AA 475-99 Kilsheimer, Douglas
VAR 99-0364

RE: Variance Application Case Number 1999-0364-V

RE: Variance 1999-0364-V, Douglas Kilsheimer

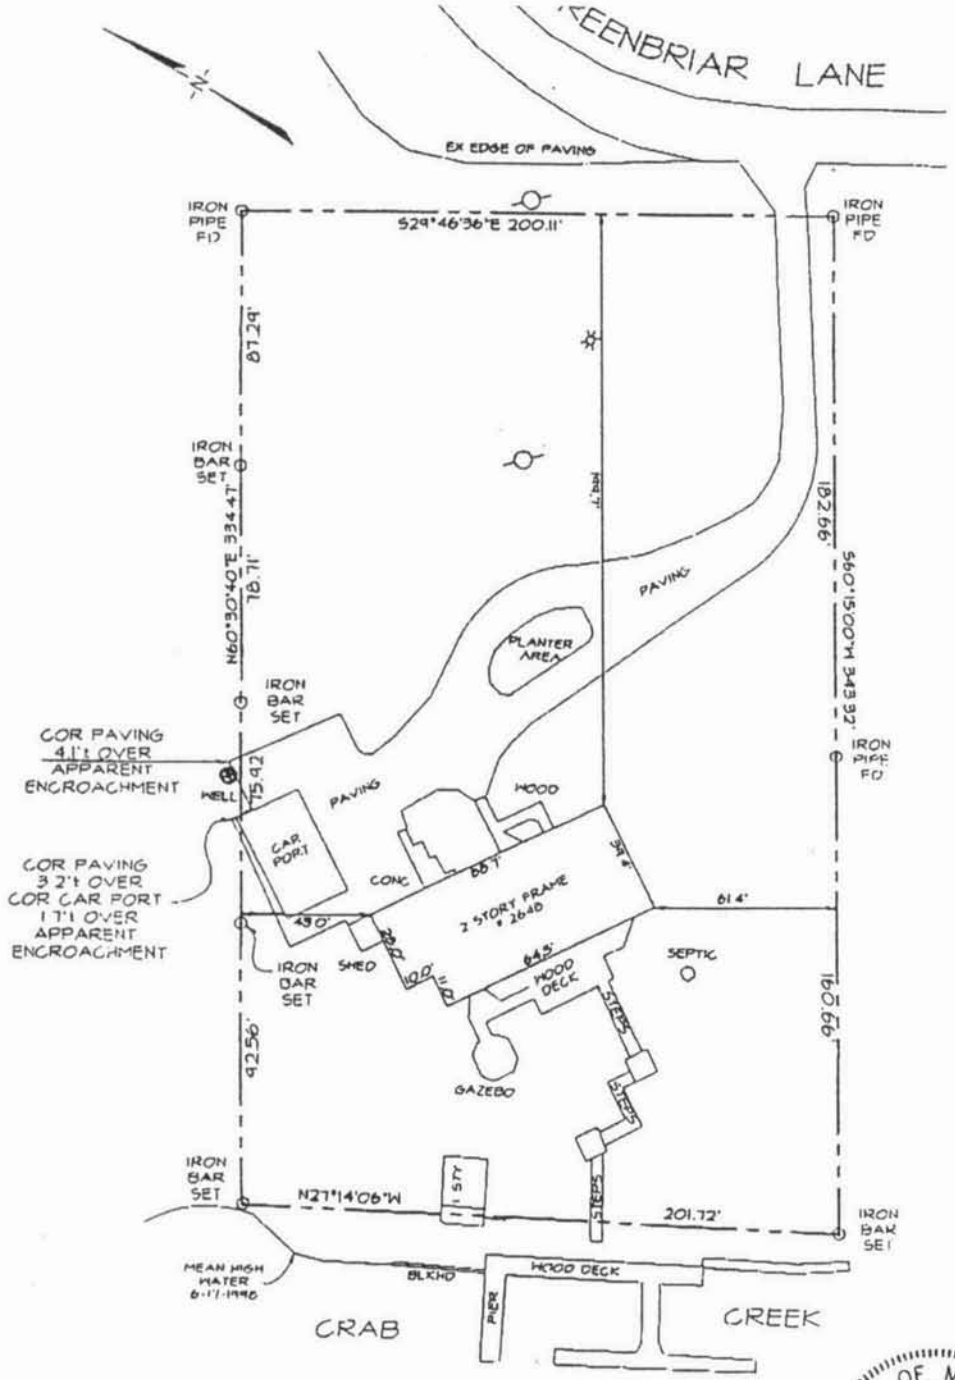
Also, please note that the site plan enclosed with the application does not accurately portray the limits of disturbance for construction of the proposed pool. The pool is proposed on steep slopes and would like involve grading and/or construction of retaining walls. Again, this disturbance in the Buffer is prohibited under County regulations.
